BCA Assessment Report

2 Murray Rose Avenue, Sydney Olympic Park

Project:	2 Murray Rose Avenue, Sydney Olympic Park
Reference No:	109504-BCA-r2
Date:	8 November 2021
Client:	Austino Property Group
Client Contact:	Will Wang
Email:	will@austino.com.au
BCA Logic Contact:	Josh Harvey
Direct:	8484 4030
Email:	jharvey@bcalogic.com.au

Figure 1 External wet area

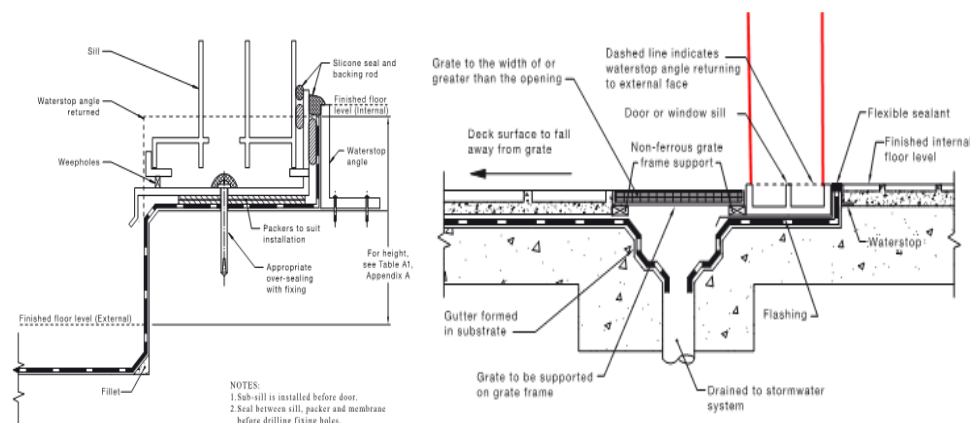
It is recommended that a Waterproofing Specialist review all external waterproofing details in particular external walkways, balconies and planter boxes which are susceptible to failure.
